Docket Item # 3
BAR CASE #2010-0244

BAR Meeting
October 6, 2010

ISSUE: Alterations
APPLICANT: Marcia Krause by Old Town Windows and Doors
LOCATION: 682 South Columbus Street
ZONE: CD/Commercial

The applicant is requesting approval of a Certificate of Appropriateness for replacement windows at 682 South Columbus Street.

Figure 3. Proposed replacement window specifications.

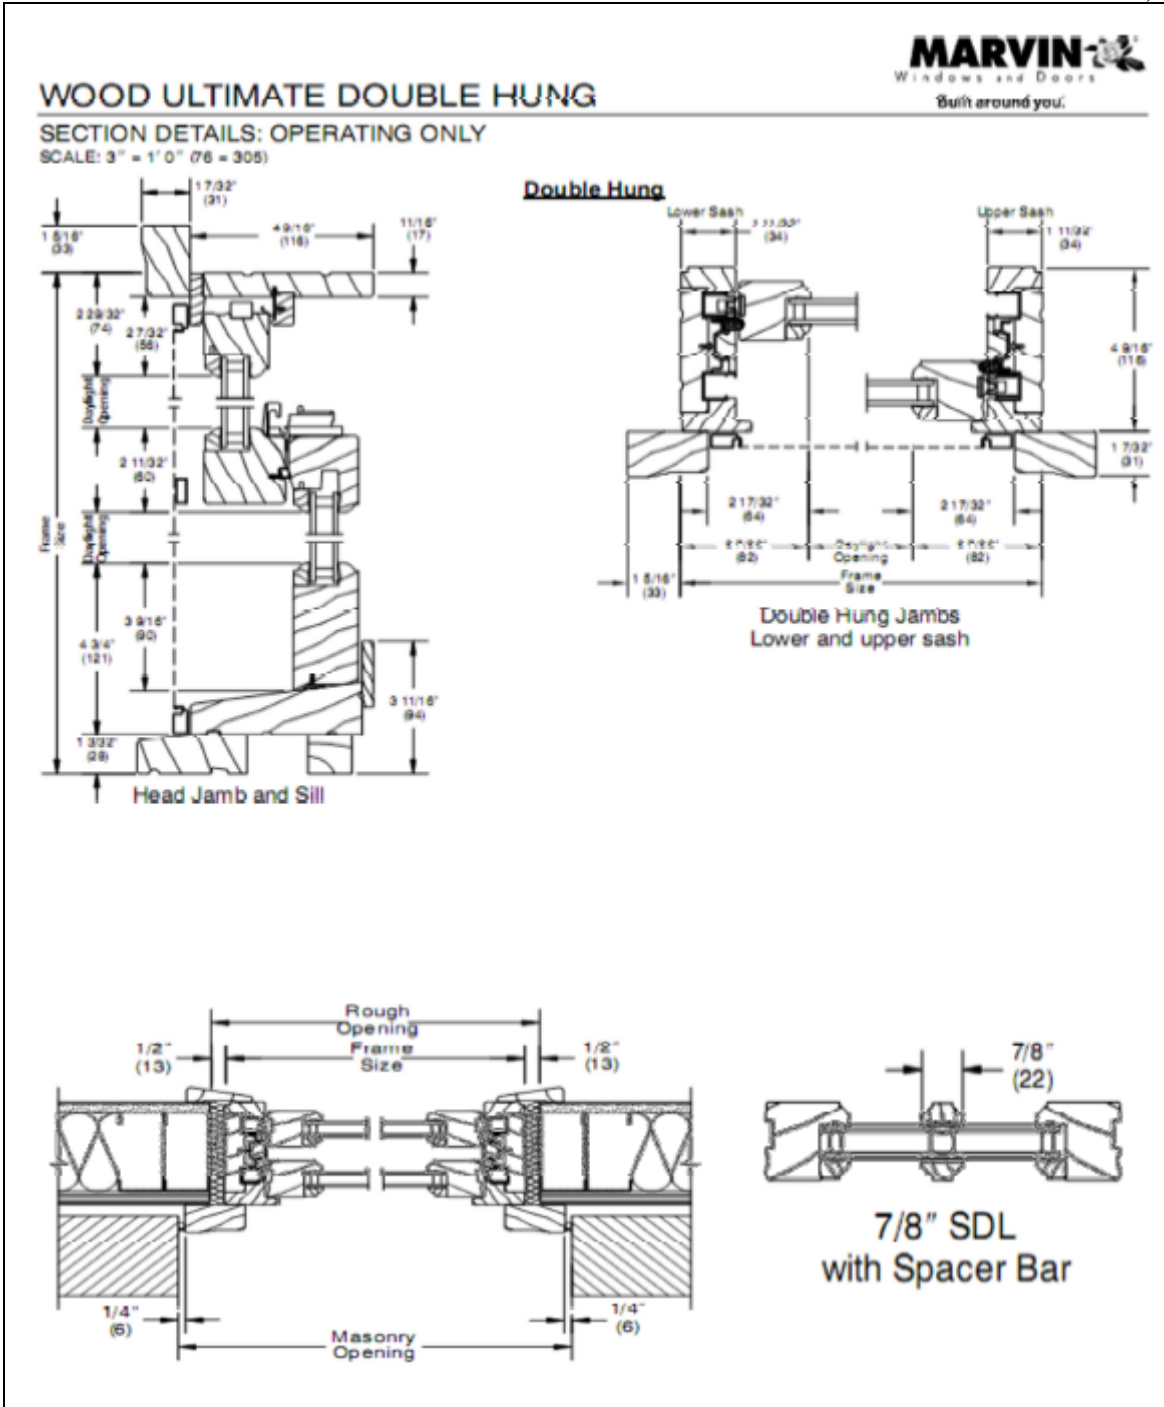
The applicant is requesting approval of Marvin Ultimate Wood Double Hung double-glazed full-frame replacement windows. The proposed windows will be simulated divided light with an interior spacer bar (dark in color) and an identical light pattern to the windows they are replacing. The 7/8" wood muntins will have a faux putty glaze profile. The windows will have LoE-366 clear glazing.

Therefore, given the age of the townhouse and the fact that the existing 6/6 light pattern and putty glazed muntin profile and size will be retained, Staff does not object to the installation of painted wood double-insulated windows, with simulated divided lights, and dark-colored interior spacer bars. Staff finds the proposed replacement windows appropriate and compatible with the surrounding buildings.
